Access Compliance Report

Public Rights-of-Way

(Curb Ramps)

Intersection ID: 15599	Main Street: COLVILLE_RD	Cross Street: EASTOVER_RD	Location: NE
ADA ID: 006007AA9AEB	Ramp Type: Perp	Initial Pass/Fail: Fail	Overall Compliance: No
Codes/Mitigation Info/Possible Solution		Field Measurements/Component Compliance	
Severity Score: 13.75

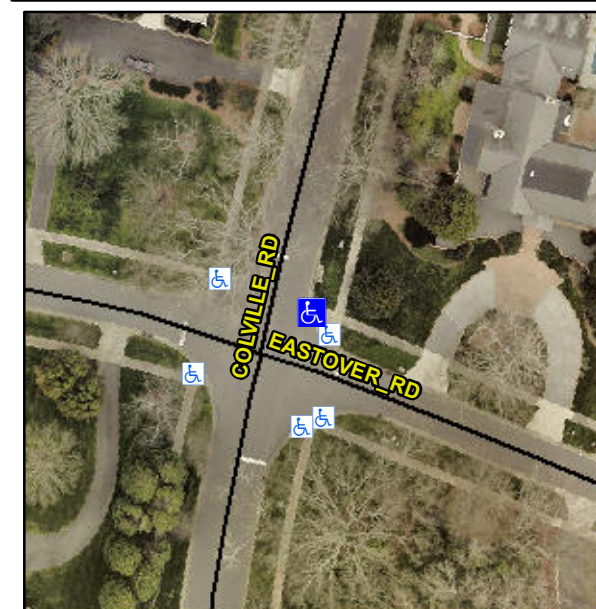
Not Found, R304.2.2, R304.5.3

Compliance	Description	Data	Compliance	Description	Data
N/A	Ramp Length (in)	48.0	No	Ramp Slope (%)	9.4
Yes	Ramp Width (in)	48.0	No	Ramp XSlope (%)	4.0
N/A	Flare Type LT	N/A	N/A	Flare Type RT	N/A
N/A	Flare Slope LT (%)	N/A	N/A	Flare Slope RT (%)	N/A
N/A	Flare Traversable LT?	N/A	N/A	Flare Traversable RT?	N/A
N/A	Landing Length (in)	N/A	N/A	DWS Provided?	N/A
N/A	Landing Width (in)	N/A	N/A	DWS Contrast?	N/A
N/A	Landing Slope (%)	N/A	N/A	DWS Length (in)	N/A
N/A	Landing X Slope (%)	N/A	N/A	DWS Full Width?	N/A
N/A	Landing Curb? (Y/N)	N/A	N/A	DWS Offset (in)	N/A
N/A	Shared Landing?	N/A			
N/A	Gutter Ponding?	N/A	N/A	Gutter Slope (%)	N/A
N/A	Gutter Lip Ht (in)	N/A	N/A	Gutter X Slope (%)	N/A
N/A	Painted X Walk1?	No	N/A	Painted X Walk2?	N/A
	X Walk 1 Direction	To NW		X Walk 2 Direction	N/A
N/A	X Walk 1 Width (in)	N/A	N/A	X Walk 2 Width (in)	N/A
	X Walk 1 Slope (%)	4.6		X Walk 2 Slope (%)	N/A
	X Walk 1 X Slope (%)	1.2		X Walk 2 X Slope (%)	N/A

Remove & Replace Entire Ramp.
